Customer Notification

78K0R/Fx3

Operating Precautions

Table C-1 No. C1 UARTF LIN Automatic Baudrate Mode (Direction of use)

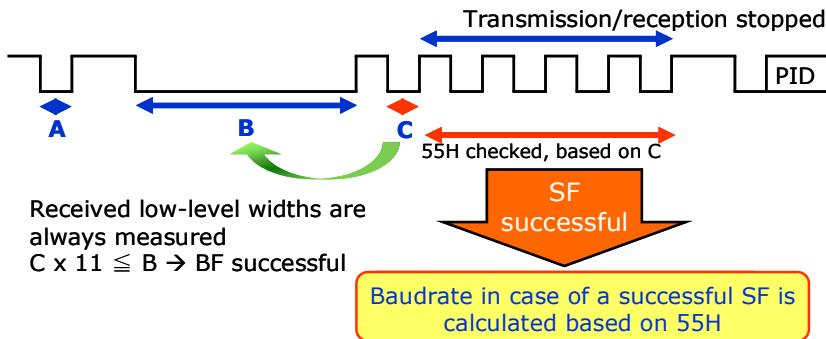
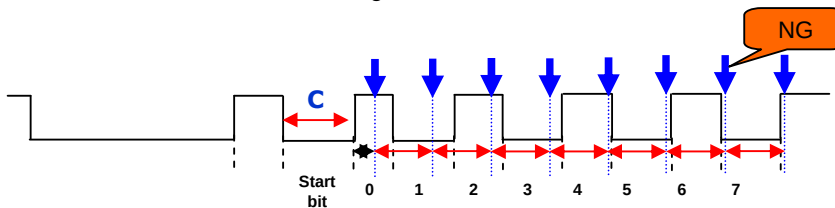
Using the Automatic Baud Rate Mode in LIN slave operation the Syncfield (SF) is automatically detected and checked. If the SF fails (no proper 0x55 received) the UARTF will abort the automatic baudrate sequence and wait for the next Syncbreakfield (SBF) to restart the sequence. If the duty cycle of the SF bits deviates from a nominal 50% duty cycle, the internal circuit may not detect the 0x55 pattern of the SF anymore and therefore would abort the automatic baudrate detection sequence. In case of an aborted baudrate detection sequence, the UARTF receive interrupt INTLRx after the PID is not generated.

However, there is no issue if the duty cycles of the SF on LRxD0 (LRxD1) is in the range of:
 $48\% \leq \text{SF duty} \leq 52\%$

However, the SF will be checked based on the low level width "C" of the Start-bit.

If the low level width of the SF will become $>52\%$, the baudrate for the successful SF detection will be changed based on "C" and no valid SF (0x55) can be received anymore. Due to this the UARTF does not generate the INTLRx and the slave will not respond.

If baudrate detection of the SF is required, the countermeasure will be the user has to switch off the Automatic Baudrate Mode and perform the SF baudrate detection by means of software.

The Automatic Baud Rate Mode (UFnMD1, UFnMD0 = 11B) can be used as described in the User's Manual. But, please take care for the item No. 2.

Table C-2 No. C2 UARTF LIN Automatic Checksum Function (Direction of use)

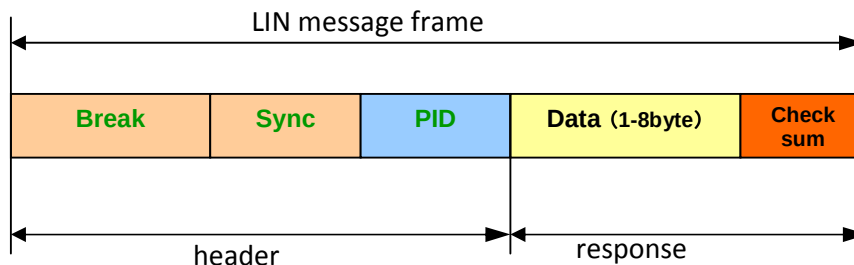
However, some messages received with a specific data pattern including an incorrect checksum will **not** be detected as **incorrect** by the UARTF in Automatic Checksum Function mode.

- The issue applies to both classic & enhanced (PID included) checksum
- It applies to response reception case
- It applies only to a very specific data / checksum pattern:
 - ➔ When the checksum calculation result is 0x00 (0xFF before inversion), no carry (9th bit position) has been added to the LSB and the received checksum is ≠ 0x00

If Automatic Baud Rate mode is selected (UFnMD1, UFnMD0 = 11B) clear the bit UFnACE = 0 to disable the Automatic Checksum Function and calculate the corresponding checksum by means of software.
